February 3, 2026

Re: 60% Design Submission
MSBA ARP Roof Replacement
Hamilton-Wenham Regional High School
775 Bay Road
South Hamilton, MA 01982
Gale JN 845190 P02 T01

Image 1: Roof Area Key Plan.

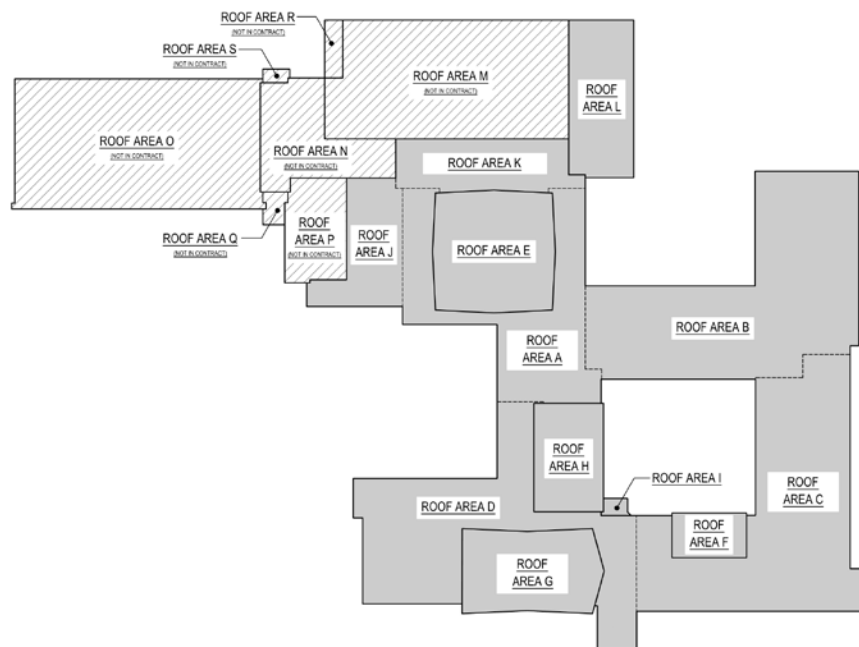
1. PEER Consultants, P.C. (PEER) sampled additional roofing materials from the roof test cuts that were performed on the EPDM roof areas (Roof Areas J, K, and L) in January 2026. PEER confirmed no asbestos was detected in the samples taken and will update their evaluation report with the additional testing. The interior finishes (i.e. gypsum wall board, joint compound, etc.), which are anticipated to be affected during the demolition of the skylights, were not accessible during our fieldwork and were not tested for hazardous materials. PEER noted that their asbestos specification could include an investigative presumed phase for the gypsum board/interior finishes at the skylights and existing throughwall flashing materials that will be replaced/impacted at designated locations. It is Gale's opinion to include the costs associated with the abatement of the presumed materials as a Unit Price should hazardous materials be encountered during construction.

2. HWRSD provided direction to remove designated skylights and infill the roof decking. During Gale's site visit on January 23, 2026, we observed sprinkler heads extending up into the skylight opening. Gale discussed the following infill options with RMF Engineering, Inc. (RMF) and how the sprinkler would be impacted. Gale intends to proceed with Option 1, unless directed otherwise by HWRSD.

3. As previously discussed, Alternate #1 has been included in the design documents which includes the installation of a fluid-applied coating over the existing roof membrane on Roof Area E (library) in lieu of the full roof replacement. Unit Prices have been carried under this alternate for membrane repairs and wet insulation replacement.

5. To fulfill MSBA's PV readiness requirement, Gale has included a new penetration box location on Roof Area A.
6. HWRSD noted that there is a separate project that is replacing the condensing unit to the library (on Roof Area A). Gale has included coordination notes on the roof area plan for the roofing contractor to include flashings of the new unit curb. Additional coordination will be required during the construction phase.
